The Commission has issued the enclosed Amendment No. ⁵⁰ to Facility Operating License No. DPR-57 for the Edwin I. Hatch Nuclear Plant Unit No. 1. The amendment consists of changes to the Technical Specifications and is in accordance with your application dated January 24, 1977, as revised by letters dated July 22, 1977 and December 20, 1977 and our letter of November 23, 1977.

EDWIN I. HATCH NUCLEAR PLANT UNIT NO. 1

AMENDMENT TO FACILITY OPERATING LICENSE

Amendment No. 50
License No. DPR-57

MANAGERIAL ORGANIZATION

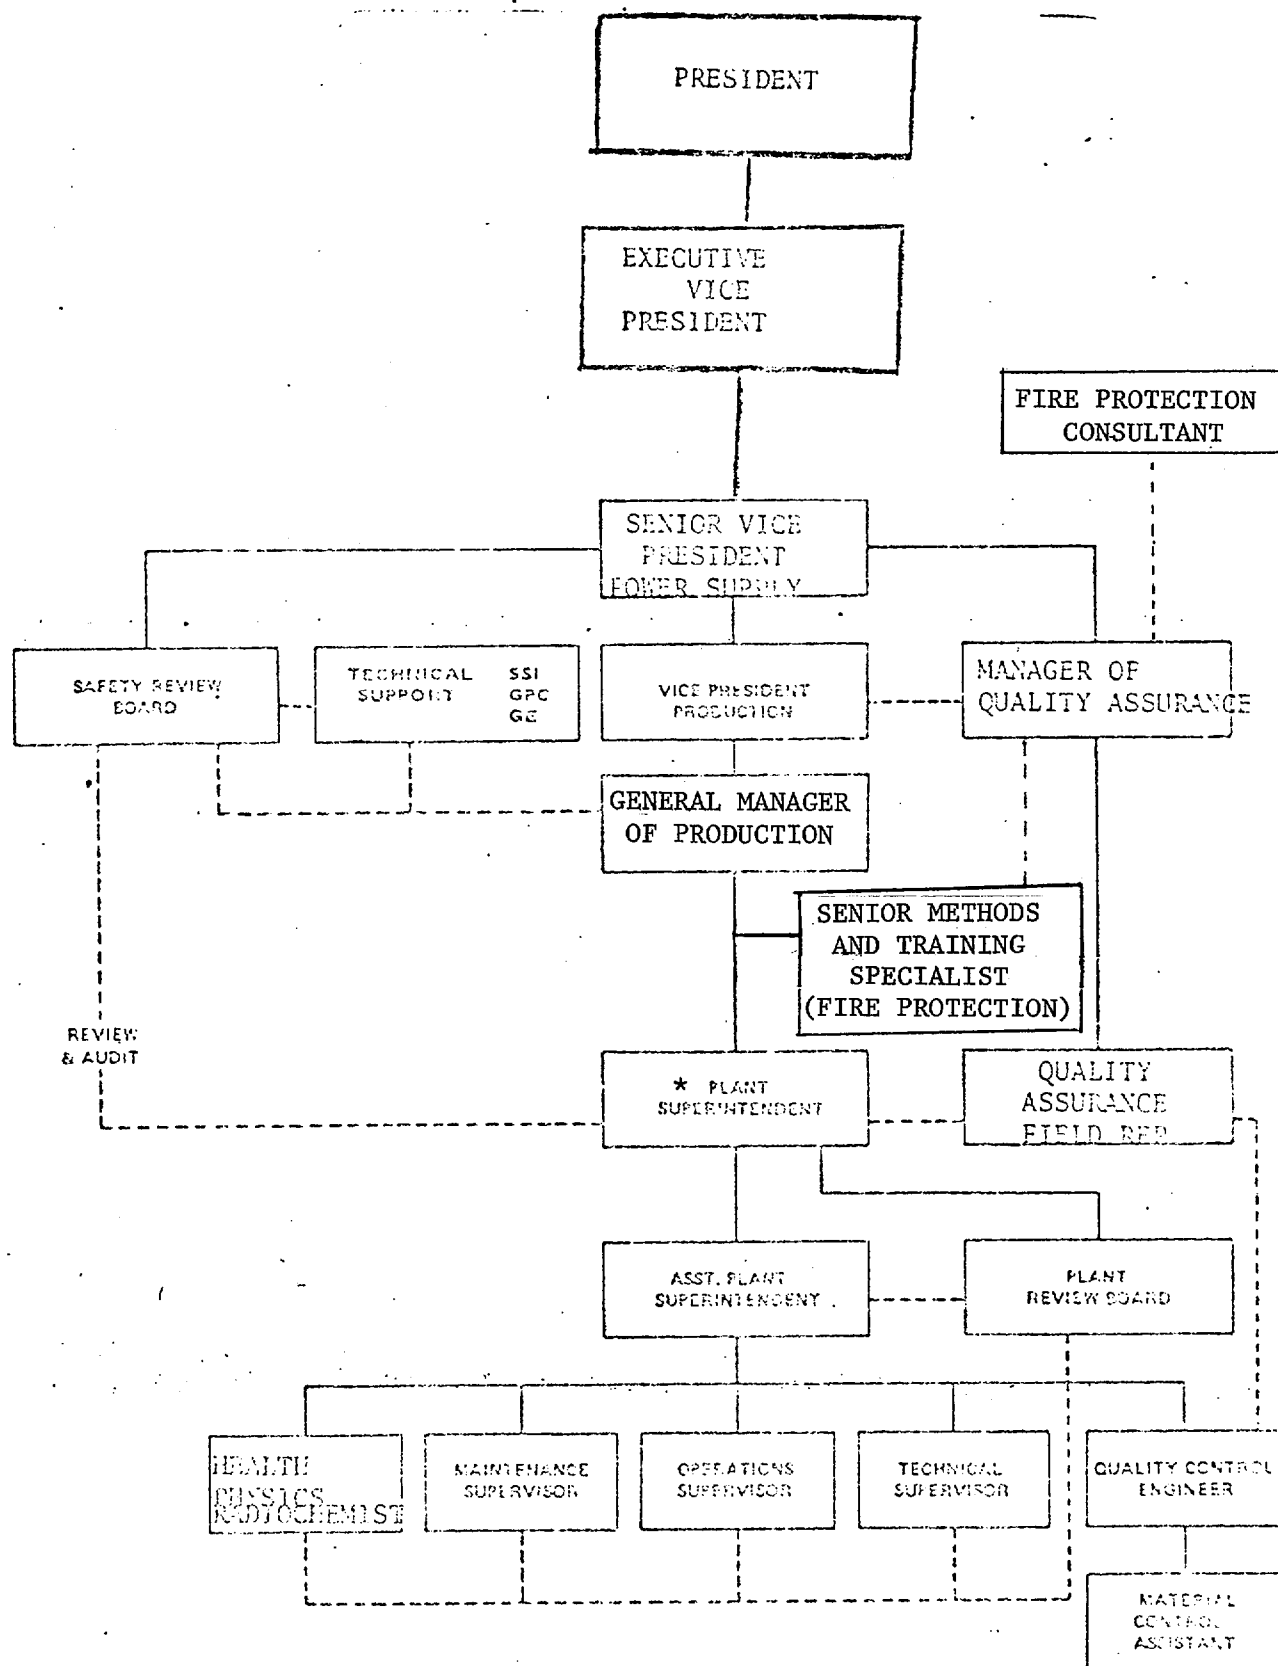
- 6.2.1 The offsite organization for plant management and technical support is shown in relation to plant supervision on Figure 6.2-1.

* Overall responsibility for fire protection
